**Doc Name:** *Lloyd street corner SVP Vent Termination route BWICs*

**Doc Reference:** OTH-PUR-TH-ZZ-SKE-A-3827

| Purpose:            | <i>2 new BWICs to be created. For the new SVP</i>    |
| Location:           | Protected Cores Lobby 07-C01/ MCC Circulation 05-C01 |

GA Plan L07 - 01 South

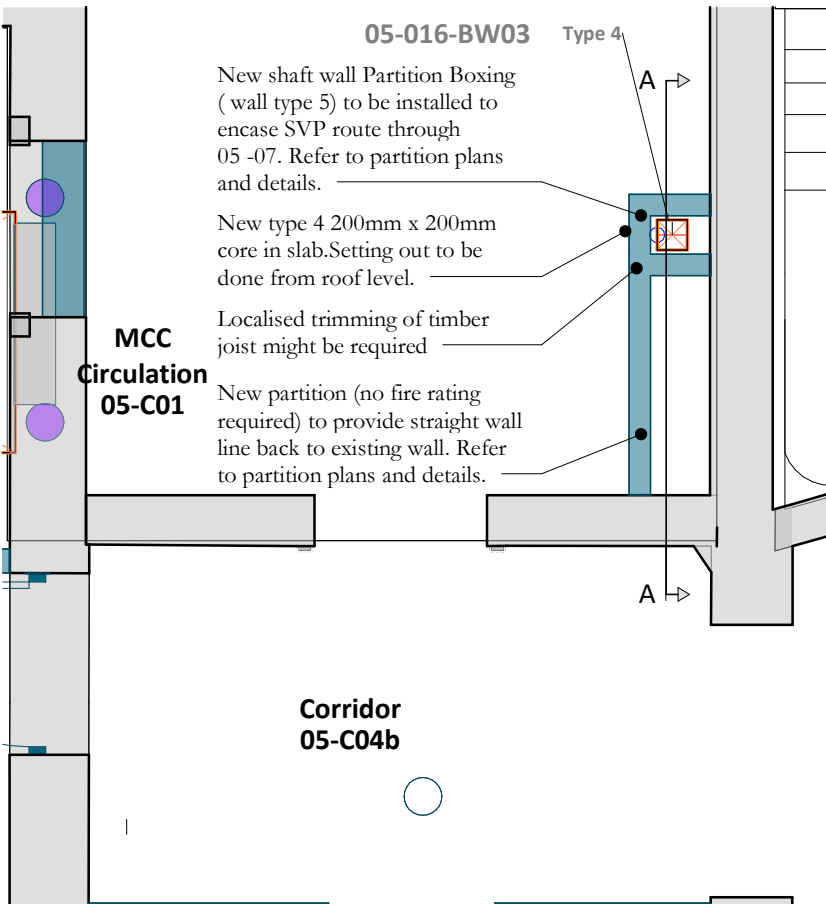
| DESIGN TEAM STATUS                                                      | EWN              | BWIC Number | Level | BWIC Type | BWIC Type Description                 | Room 1 | Room 2 | Fire Rating | Comments                                                                                                                       | Approx Depth | Approx Width | Approx Height | Approx Offset From Level | Revision                                                       |
|-------------------------------------------------------------------------|------------------|-------------|-------|-----------|---------------------------------------|--------|--------|-------------|--------------------------------------------------------------------------------------------------------------------------------|--------------|--------------|---------------|--------------------------|----------------------------------------------------------------|
| Co-ordinated and ready For Validation<br>(Design Team Updates Required) | Arup1-EWN-000305 | 07-C01-BW01 | 7     | Type 4    | Opening in structural composite floor | 07-C01 | 05-C01 | NA          | New 200x200 core in slab for SVP to be positioned within the floor joist spacing and through existing lath and plaster ceiling | 200          | 200          | 200           | 0                        | Rev 12: NEW BWIC added following coordination with design team |

GA Plan L05 - 01 South

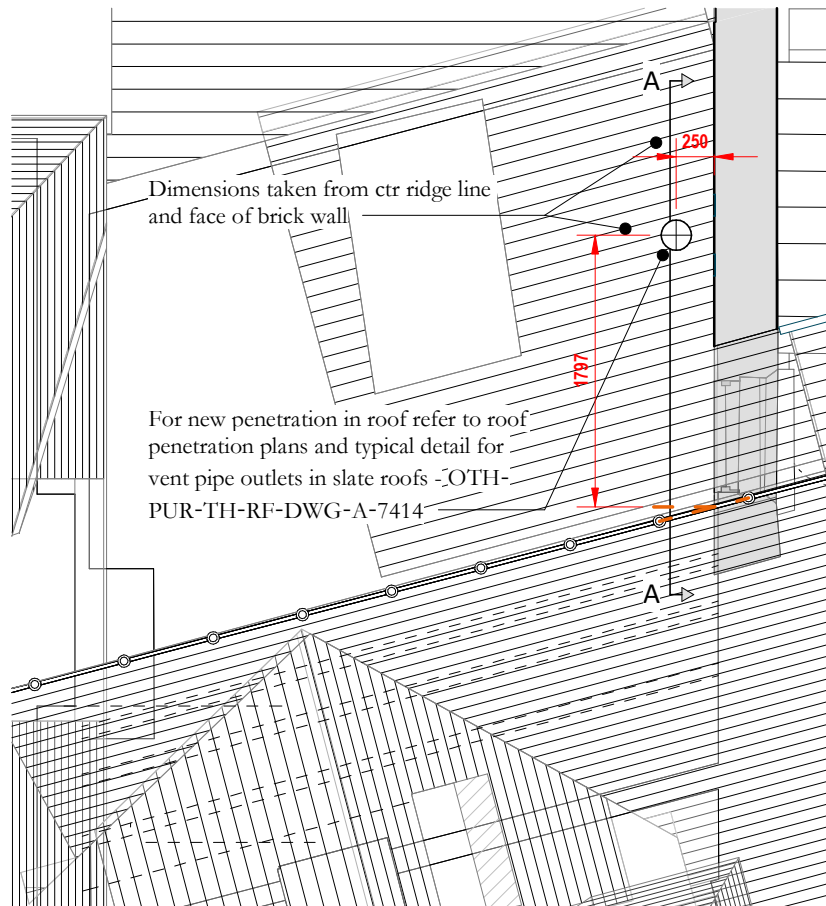
| DESIGN TEAM STATUS                                                      | EWN              | BWIC Number | Level | BWIC Type | BWIC Type Description                 | Room 1 | Room 2 | Fire Rating | Comments                                                                                                                       | Approx Depth | Approx Width | Approx Height | Approx Offset From Level | Revision                                                       |
|-------------------------------------------------------------------------|------------------|-------------|-------|-----------|---------------------------------------|--------|--------|-------------|--------------------------------------------------------------------------------------------------------------------------------|--------------|--------------|---------------|--------------------------|----------------------------------------------------------------|
| Co-ordinated and ready For Validation<br>(Design Team Updates Required) | Arup1-EWN-000305 | 05-016-BW03 | 5     | Type 4    | Opening in structural composite floor | 05-C01 | 03-002 | NA          | New 200x200 BWIC for new SVP in existing slab                                                                                  | 200          | 200          | 535           | 0                        | Rev 12: NEW BWIC added following coordination with design team |

Section A-A

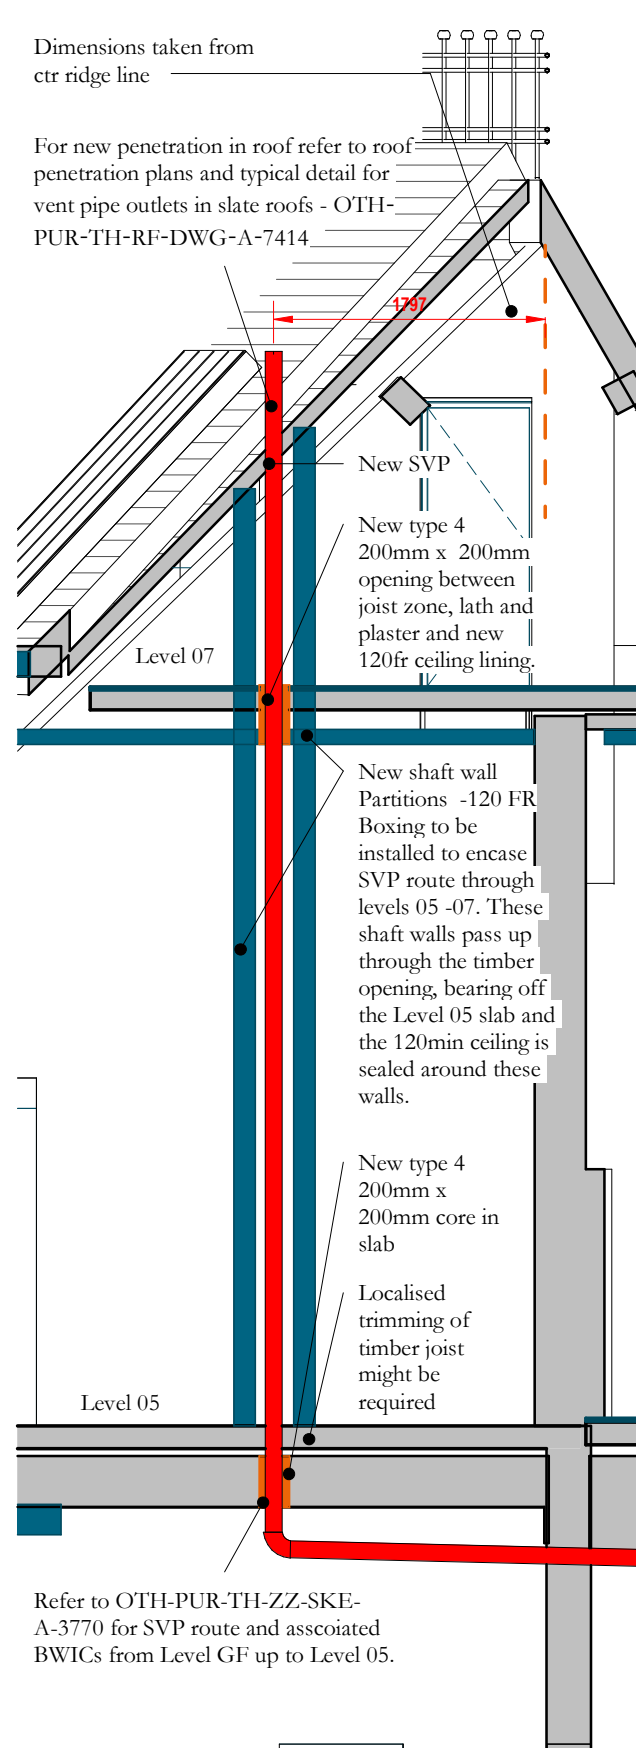
Please note setting out for cores ( level 05/07) and pipe penetration in the roof to be done from the roof level.
